# 849 NW MARKET ST

3035550-LU // ADMINISTRATIVE DESIGN REVIEW // RECOMMENDATION DOCUMENT SUBMITTAL  
27 SEPTEMBER 2021  
REVISED 15 NOVEMBER 2021

# Response to EDG Priorities and Recommendations

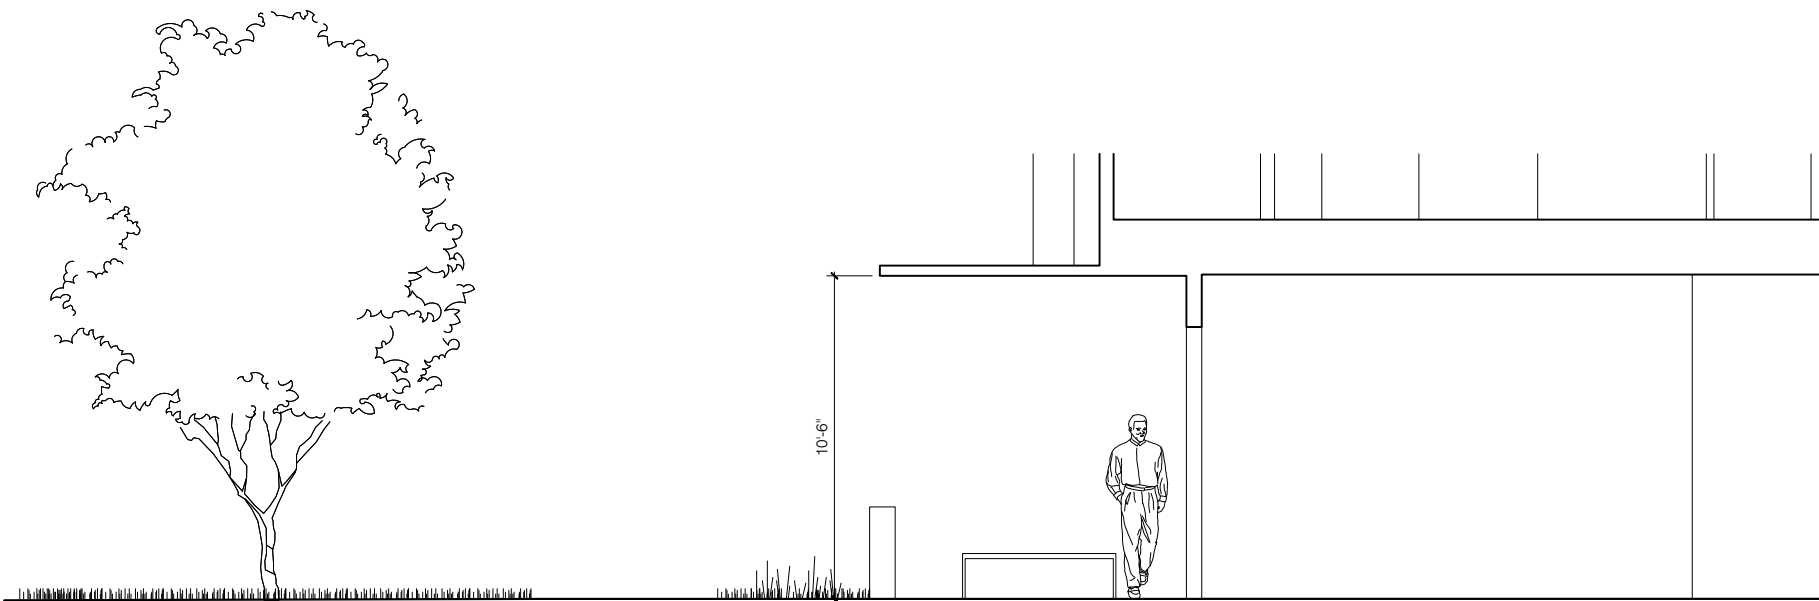
c. Staff questions whether the open space at the southeast corner can successfully function as usable amenity area while also serving as a temporary loading space as well as potential trash staging location, but supports the precedent images for this area provided on pg. 35 of the EDG. (DC1-C-3 Multiple Uses)

d. The design of the open space should emphasize use by people rather than vehicles through high quality textured paving materials, lighting, landscaping, furniture and other design elements. Staff notes that the overhead elements such as the canopy and trellis illustrated in the precedent images are also successful at creating a people-oriented space. (DC1-C-3 Multiple Uses, DC3-B Open Space Uses and Activities, DC4-D Trees, Landscape and Hardscape Materials)

(3) The open space at the southwest corner will serve as a loading berth. Site lighting, a low wall and fence to the south, small scale pavers, and power can be provided to allow for flexible use of the space by tenants and local businesses. Trash staging will now be in the parking lane of the street that will enhance the usability of the south court.

(4) The clear definition of the loading berth on the south side with a low wall and a steel and wood screen, provide a semi-private people-oriented space. The structure of the screen will provide opportunities to introduce temporary lighting. High quality, small scale, paving materials will emphasize use by people. A block pattern using two tones of paver will be used to define the loading berth and access aisle within a larger graphic pattern extended over the entire court. This design element will emphasize the use by people by integrating the required markings within a larger overall pattern.

ground level plan

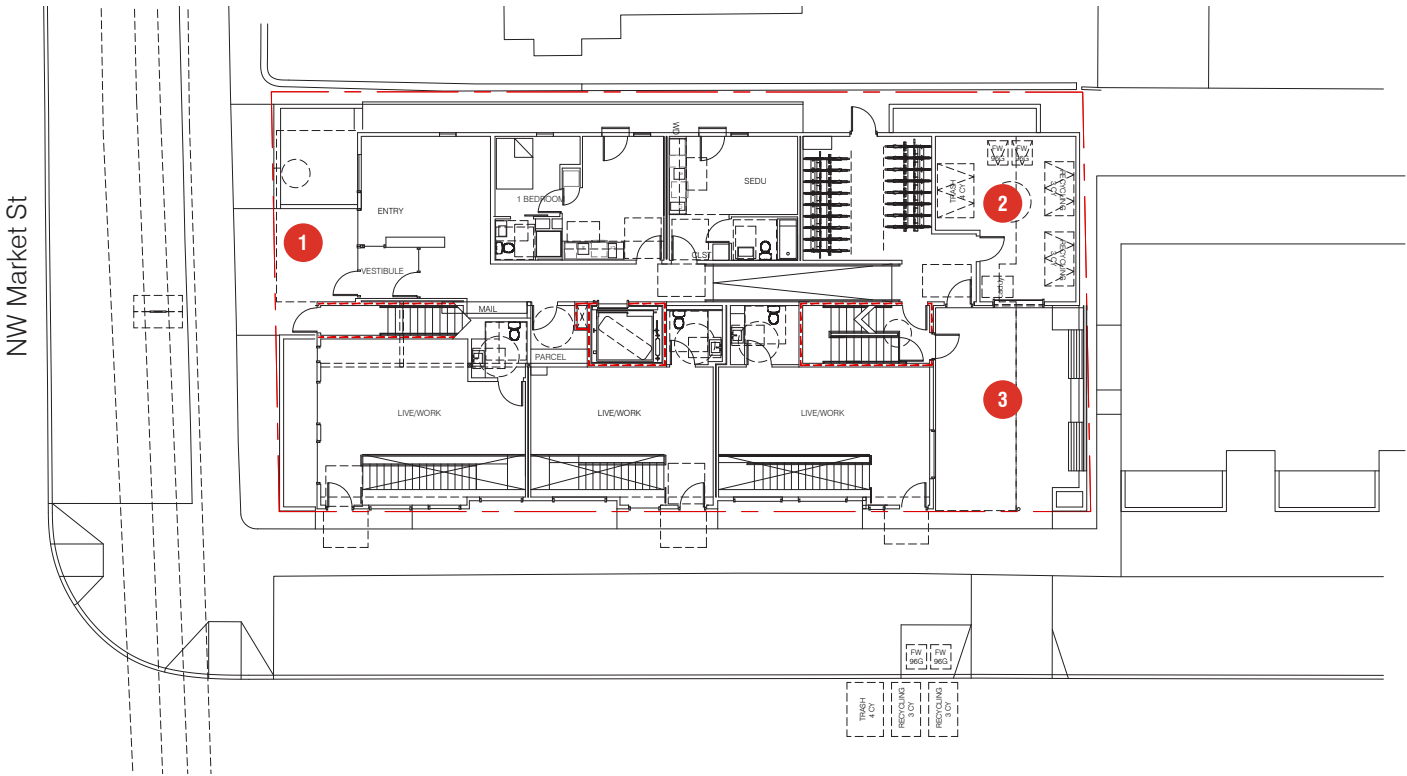
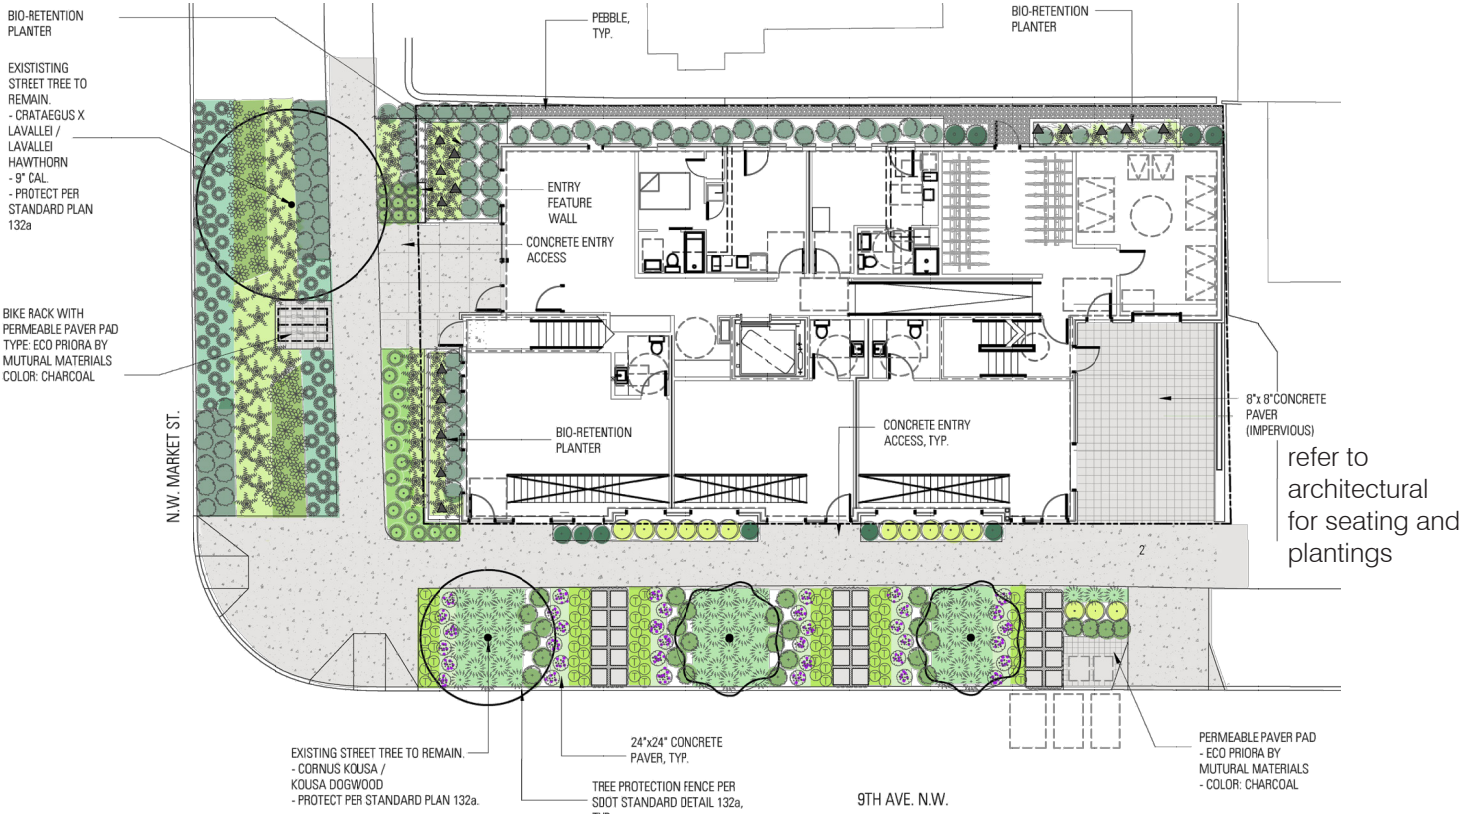
e. Staff strongly encourages the applicant to work with SPU to determine whether it is possible to accommodate interior trash staging to minimize impacts to the open space. (DC1-C-3 Multiple Uses, DC1-C-4 Services Uses)

We worked with SPU to reduce the impacts of trash staging on the open space. By increasing dumpster sizes, we reduced the size of the trash room and are allowed to stage in the right of way, one day per week. The reduced waste room also allows for a larger bike room that will consolidate all bike storage at the entry level.

east elevation

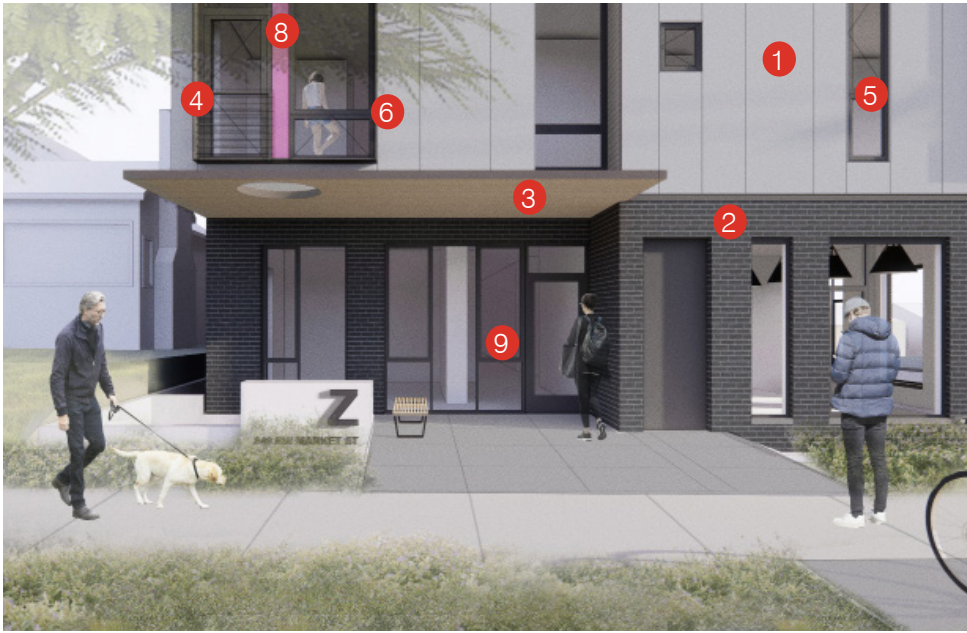
b. Minimize the impact of blank walls at the waste storage room on the amenity area with design treatments that provide human scale. (DC2-B-2 Blank Walls)

c. Thoughtfully compose the east façade to minimize privacy impacts to the adjacent single-family neighbor. (CS2-D-5 Respect for Adjacent Sites, DC2-B-1 Façade Composition)

(2) The wall will be clad with brick to carry the quality of materials and texture to the exterior wall of the waste storage room. The wood screening along the south lot line folds onto the brick wall and the building logo “Z” will be cut into the human scaled and textured layering of materials.

(3) The brick base will be carried around the ground floor of the east façade. A window pattern of narrow vertical windows will provide texture and scale to the façade and manage the amount of view into and out of the dwelling units.

street view of live/work units

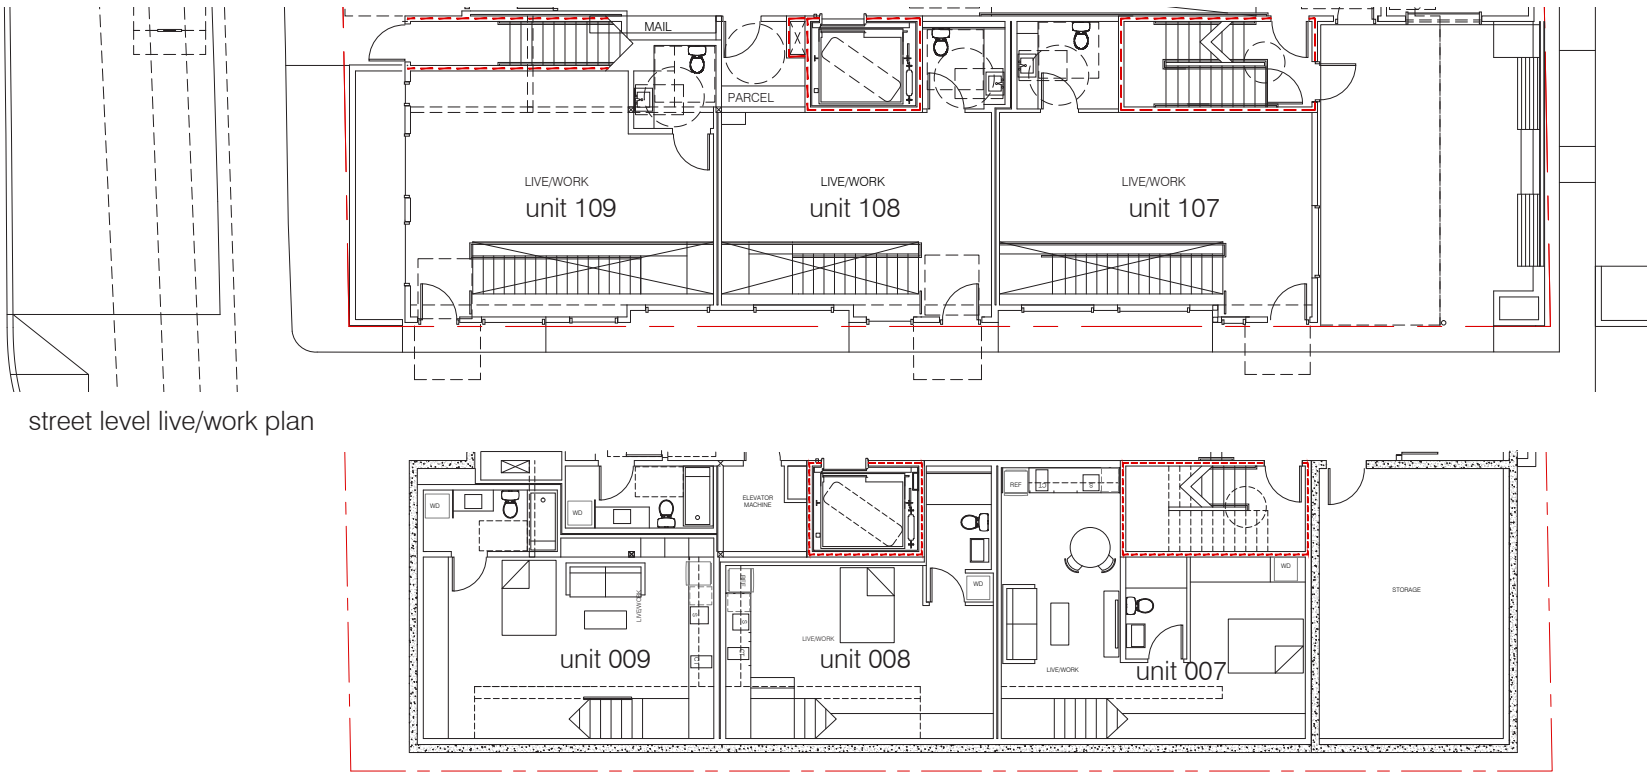
- a. Staff supports the transparent façade at the live/work units as shown in option C. (PL3-B-3 Buildings with Live/Work Units)
- (3) A high level of transparency into the live-work units has been maintained. The extent of brick and openings seek to create a sturdy base while maximizing openness.
- b. Design the live/work units to maximize the amount of natural light that reaches the below grade level while maintaining an active façade. (PL3-B-3 Buildings with Live/Work Units)
- (4) The stair to the lower level of the live-work units has been rotated to align with the west façade to allow a greater amount of daylight to reach the lower level. An open railing along the stair will allow for visual transparency into the work portion of the unit. Deep window sills will allow for flexible use of these space for signage and/or display.
